$\frac{1057 \, \text{Gibsons Way}}{\text{Mixed Use Development}}$

**REZONING & DEVELOPMENT PERMIT – Re-Submission**

## **Re-submission**

## **Elevations and Massing**

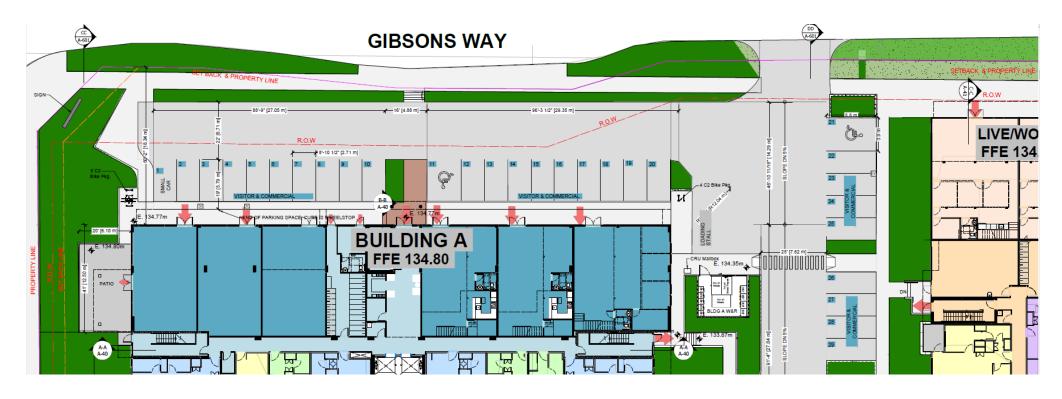
Feedback	PCRE Comments
Support of 6 <sup>th</sup> storey considering a new parking study is done. Gibsons has had support in the past to further reduce parking ratios.  There is a high demand for rental housing.	An additional storey was added on both buildings supported by a revised parking study and a resulting 0.97 per unit parking ratio. Comparable projects within the Municipality have observable parking demand ratios ranging from 0.41 to 0.67 per residential unit. Given our pedestrian and transit friendly, location, and our proposed addition of one shared car, we deem our parking ratio to be sufficient.
Change massing/articulation on the top storey, remove side units or step back. Could add windows to the end of the buildings.	Top floor end units have been re-designed and stepped back to break up massing and monotony and create visual interest at key corners. Additional windows have been incorporated.

## **Commercial Viability**

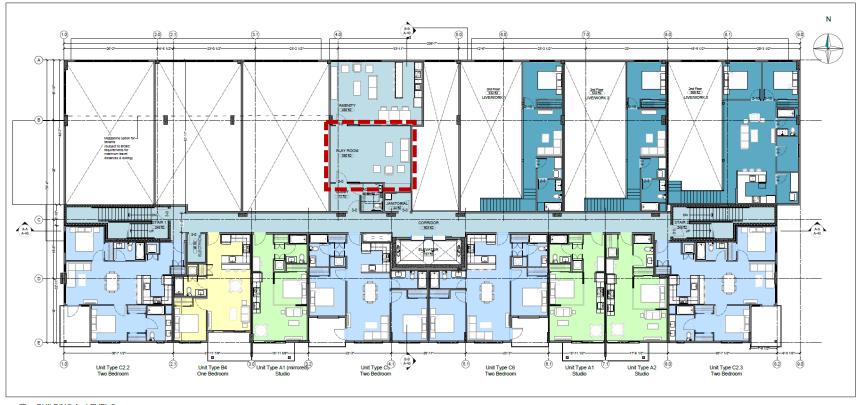
Move building A closer to the street and move parking to the back. Soames Place put their parking on the side. Vast majority of parking is on the side or behind. There is limited demand for commercial space in the market, therefore the sole front parking row of 20 stalls is critical to ensure viability and success of any commercial units and the mixed-use concept. Soames place experienced unit turnover.
